Response to September 14, 2006 Comments
Countryside Executive Golf Course
2506 Countryside Boulevard
Clearwater, Florida
HSA Project Number 601-5982-00

Subject: **Response to September 14, 2006 FDEP Comments**
Countryside Executive Golf Course
2506 Countryside Blvd.
Clearwater, Florida
HSA Project Number 601-5982-00

SHEET TITLE
MONITORING WELL
MW-2 AND
VICINITY

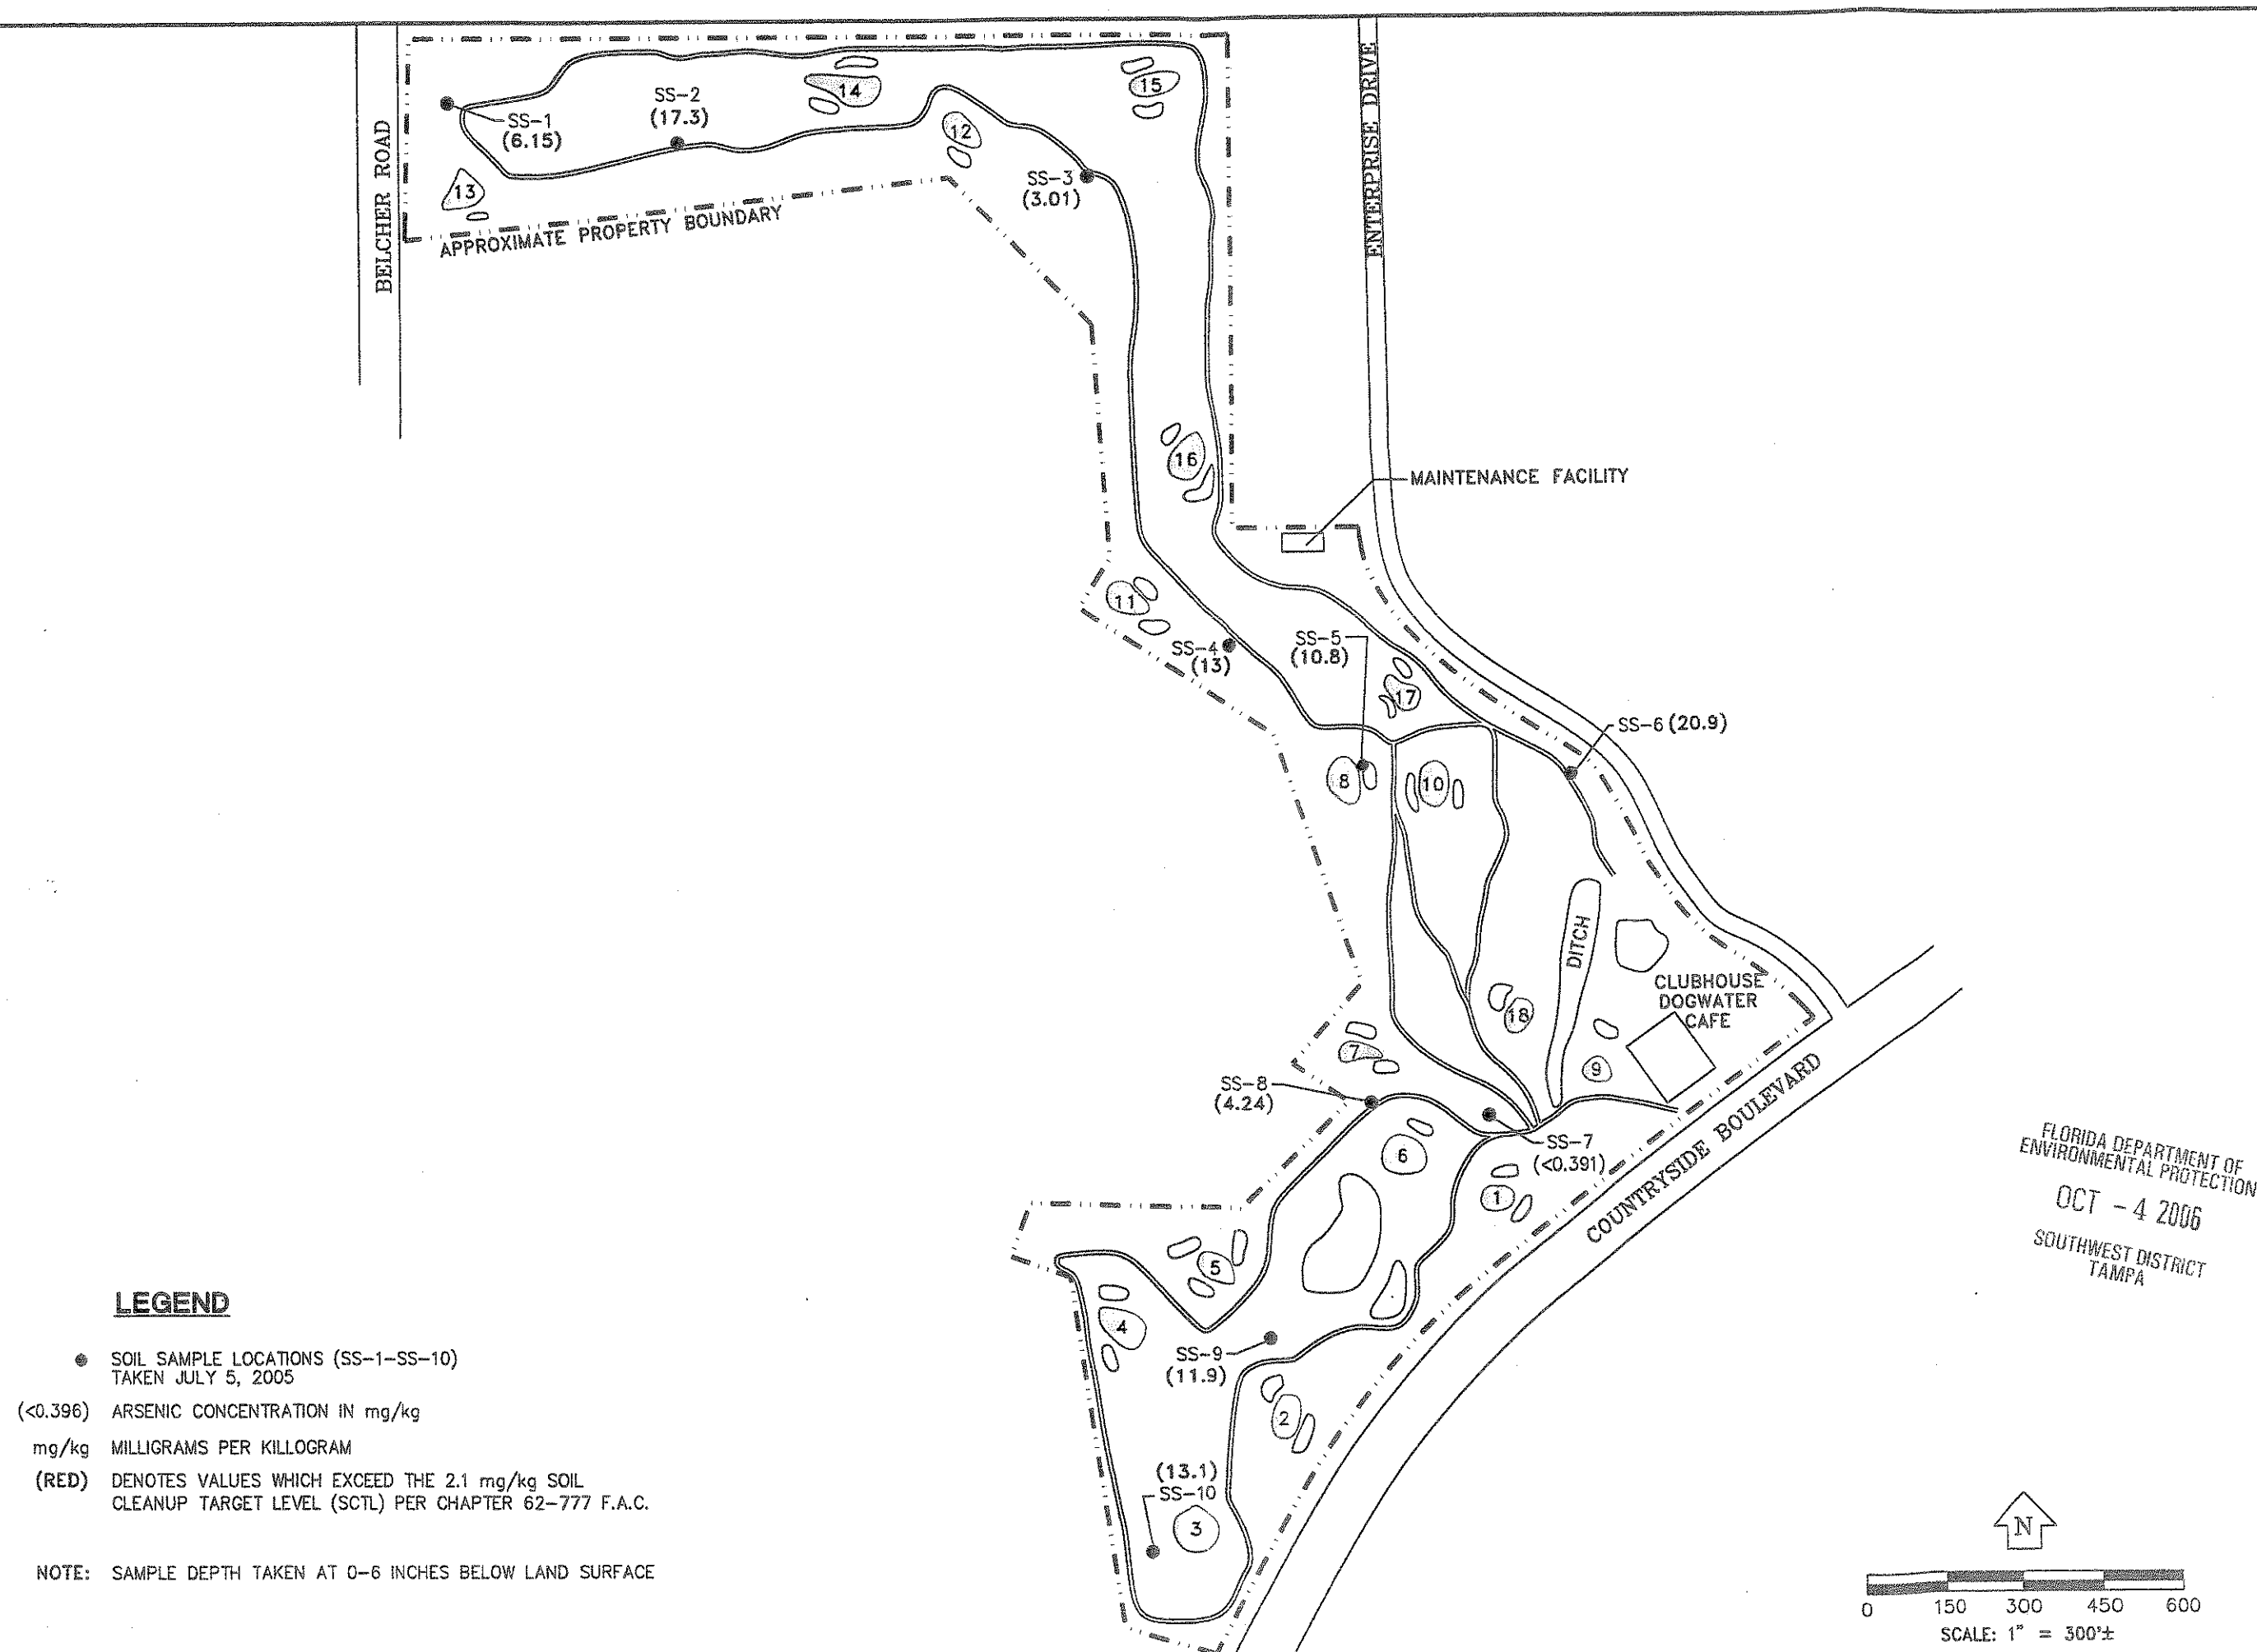
Comment 6: *No isoconcentration contour maps of groundwater are included. These should be included in the next SARA submittal.*

Response: Figure 3 of the Interim Source Removal Plan and Groundwater Monitoring Plan dated July 2006 included an isocontour depicting the approximate extent of arsenic in groundwater near the maintenance facility. An isocontour for the vicinity of monitoring well MW-2 is included in **Figure 1B**.

SOIL ARSENIC
CONCENTRATIONS
(6"-2')

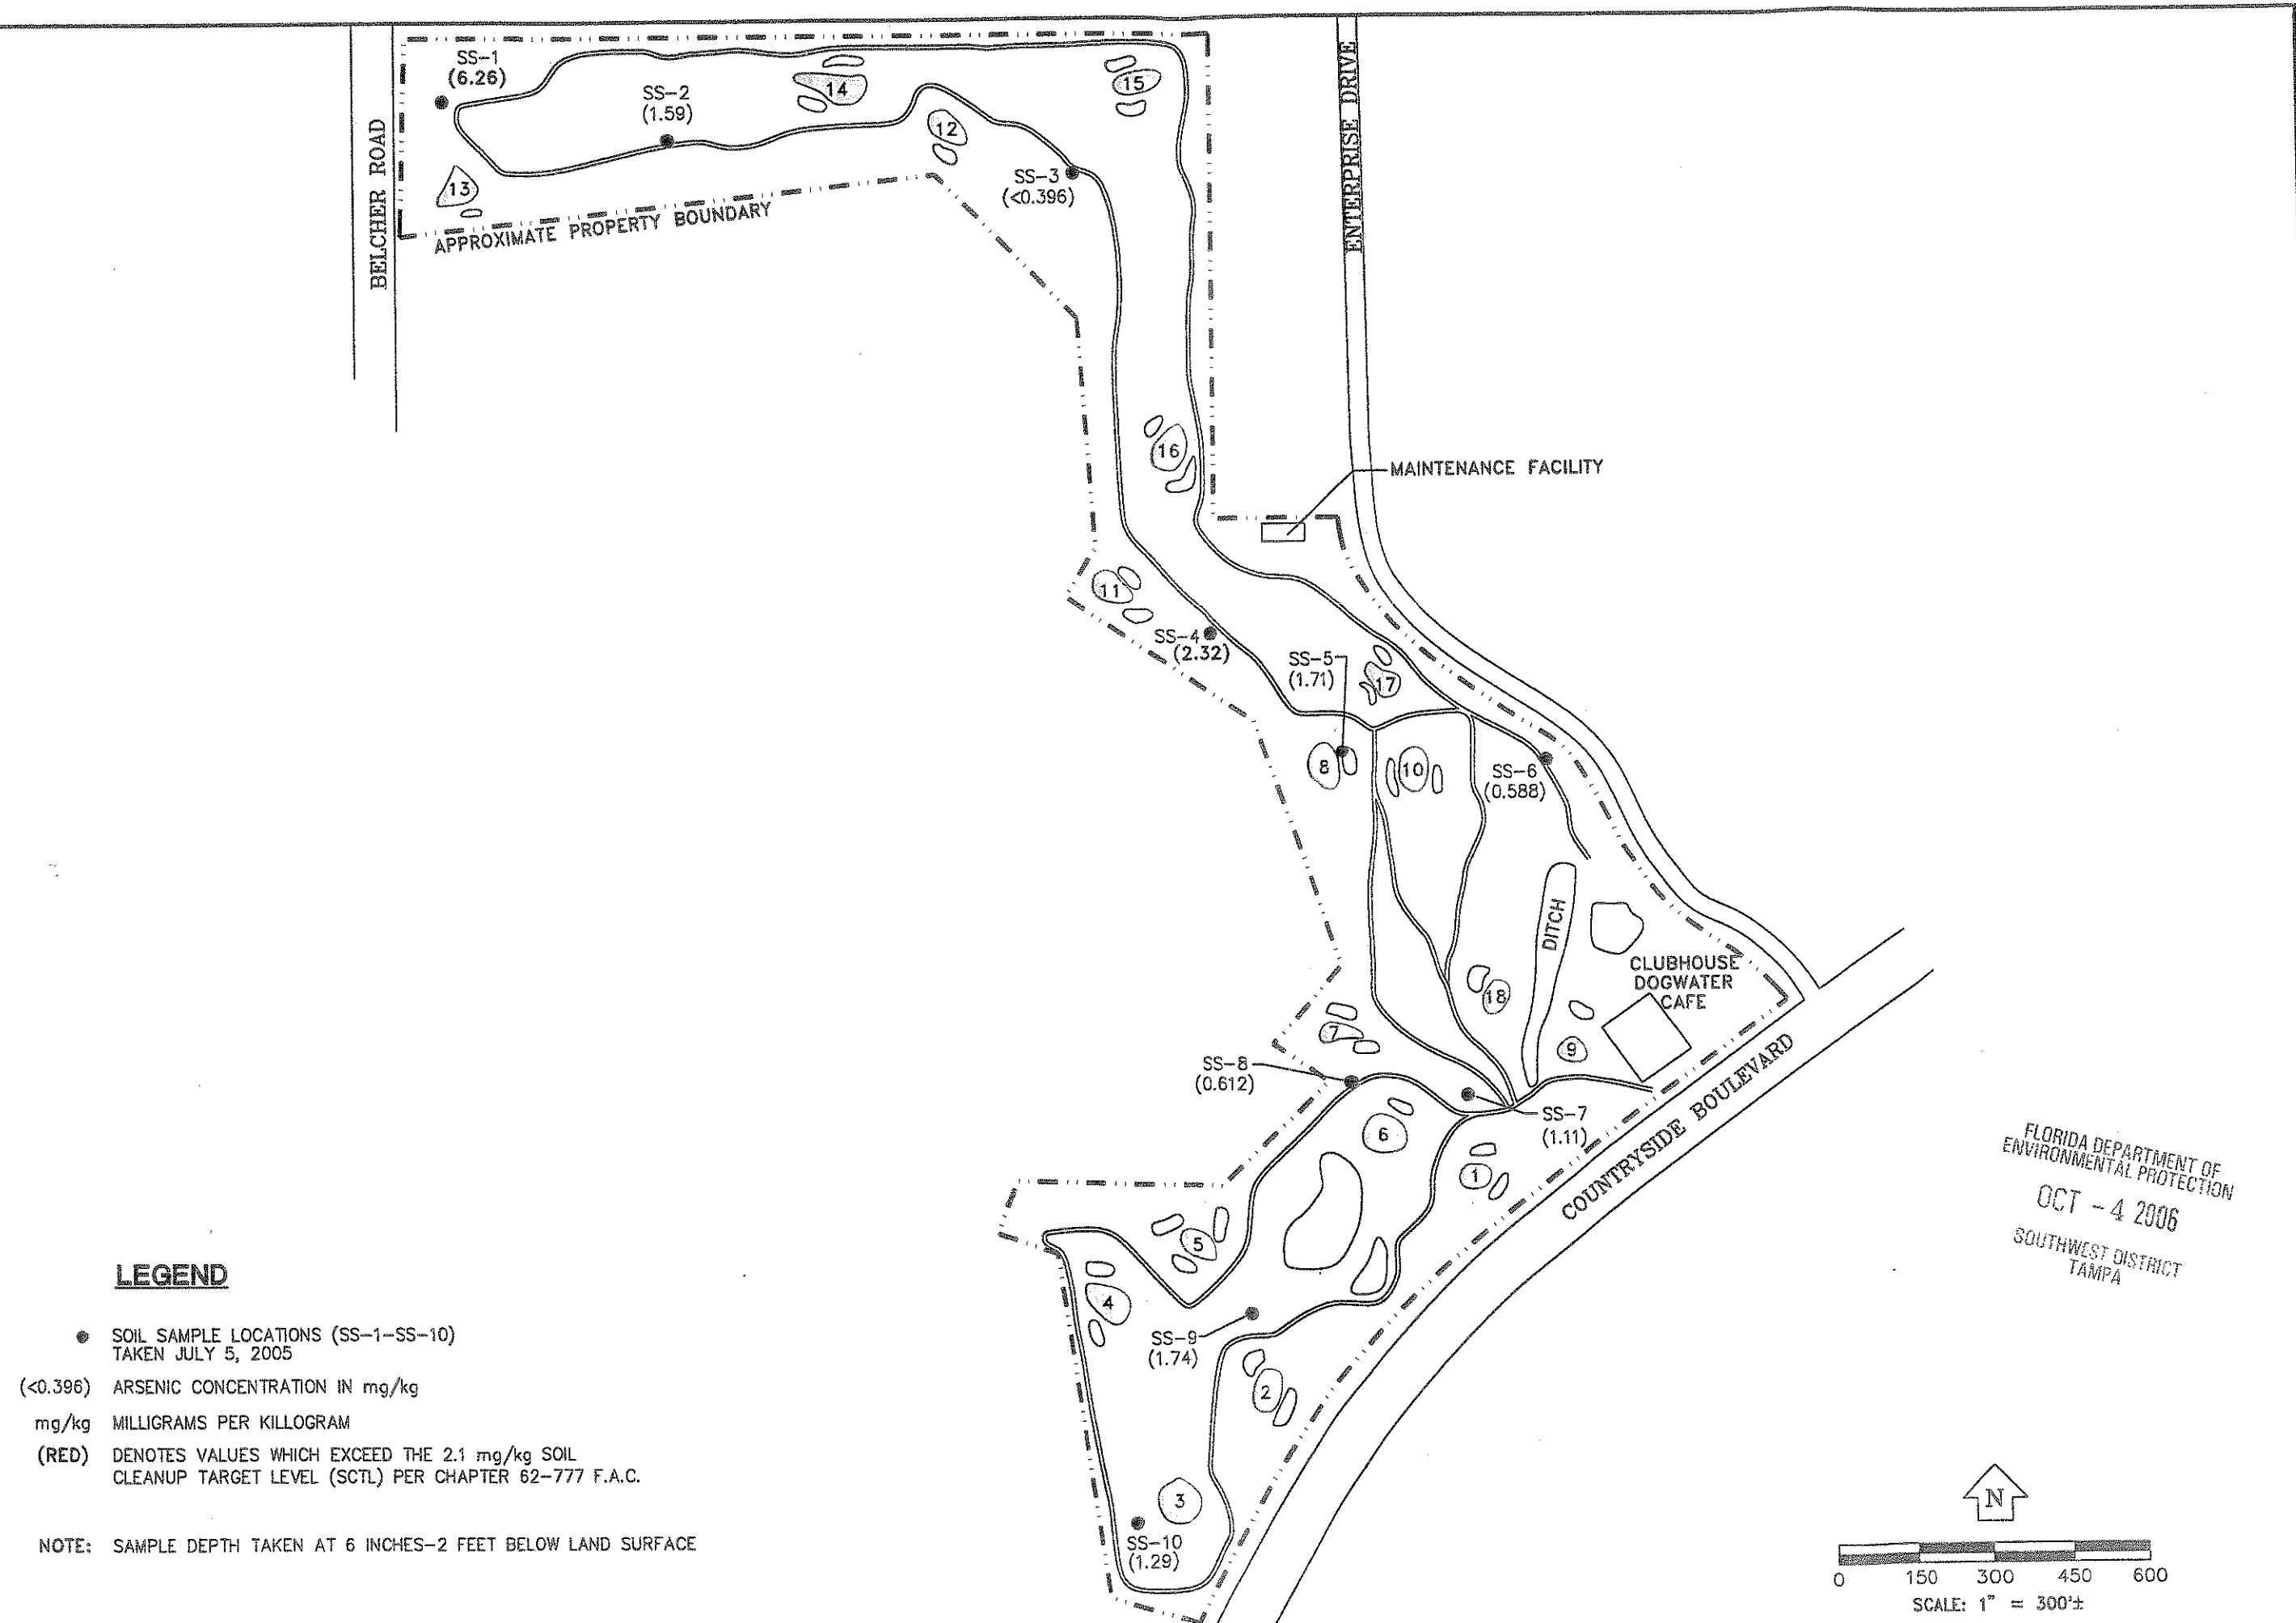
Comment 1: *Soil isoconcentration maps of arsenic by depth are needed to indicate where the site has been delineated.*

included under Chapter 62-780, Florida Administrative Code (FAC), soil arsenic impacts were evaluated for depths ranging from land surface to 6-inches bls (Figure 2), 6-inches to 2 feet bls (Figure 3), 2 to 4 ft bls (Figure 4), and 4 to 6 ft bls (Figure 5). The depth to groundwater across the site is approximately 4 to 6 ft bls.
